FIRE SAFETY INSPECTION REPORT

BELLISSIMA APPARELS LIMITED
SHOPPING AREA, BSCIC, INDUSTRIAL ESTATE,
TONGI

ACC  **RD**
on Fire and Building Safety in Bangladesh

May 8, 2014

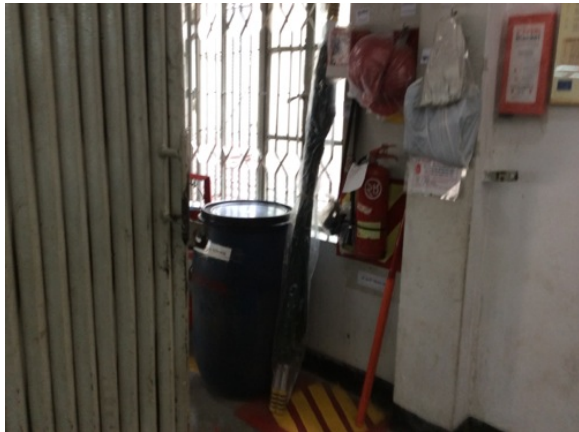
F-1	Fire Rated Construction	The boiler room on the ground floor is not separated by fire-rated construction due to a non-rated door and unsealed penetrations.	Separate the boiler room by a minimum 2-hr fire-rated construction. Seal and/or protected all openings to maintain the required fire separations	Within 3 months
-----	-------------------------	--	--	-----------------

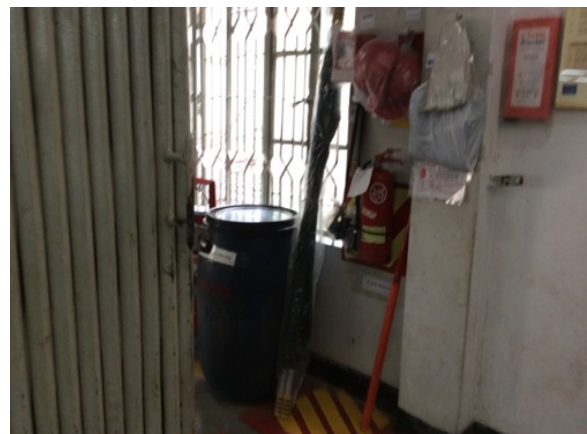
F-4	Fire Rated Construction	Storage for the packing section is open to the factory floor.	Provide dedicated storage rooms separated by minimum 1-hr fire-rated construction.	Within 3 months
			<p>Where separate storage rooms are not feasible, provide defined storage areas and limit the storage arrangement as follows:</p> <ul style="list-style-type: none"> - Maximum height of 2.4m and maximum area of 23m² - If sprinkler protected: maximum height of 3.66m and maximum area of 93m² 	
			<p>Separate areas of unenclosed combustible storage by a minimum clear distance of 3m.</p>

F-5 Egress

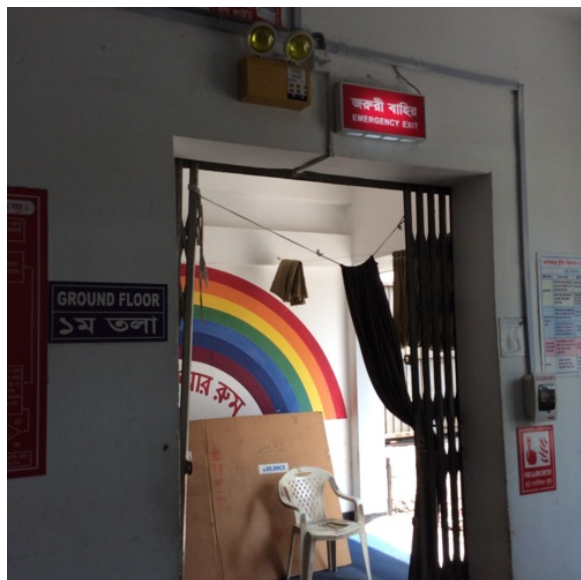
Egress doors and gates with locking features are provided at all exit stair openings and discharge.

Remove locking features from all egress doors and gates.

If locks are required for security reasons, utilize special door locking features complying with NFPA 101.

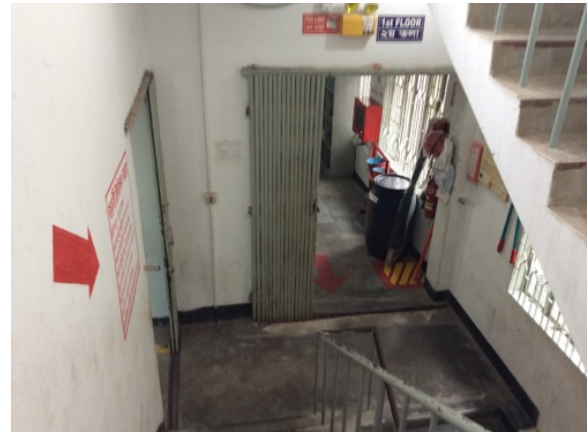
F-8	Egress	Dustbins were observed in the exit stairs.	Remove all storage from exit stairs and egress paths.	Within 3 months
-----	--------	--	---	-----------------

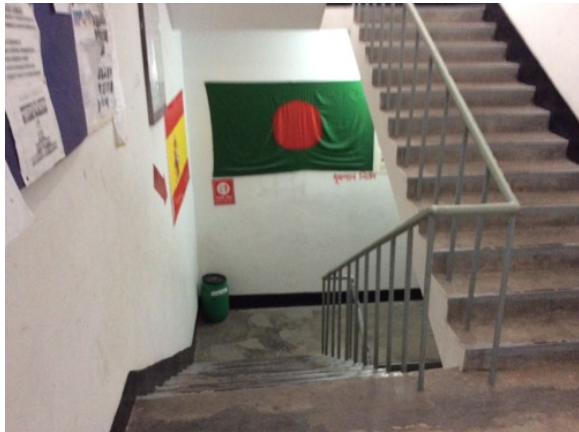
F-9	Egress	The south exit stair discharges inside the building. It is served by an exit passageway, but the passageway is not separated from the rest of the building.	Provide 1-hr fire-rated exit passageway leading directly outside (use vestibules to separate any storage areas).	Within 6 months
F-10	Fire Protection	The fire alarm system is antiquated, not a listed system, and does not provide alarm and notification features consistent with acceptable standards.	Replace the fire alarm system with a new, listed addressable fire alarm system in accordance with NFPA 72.	Design within 4 months, install within 9 months
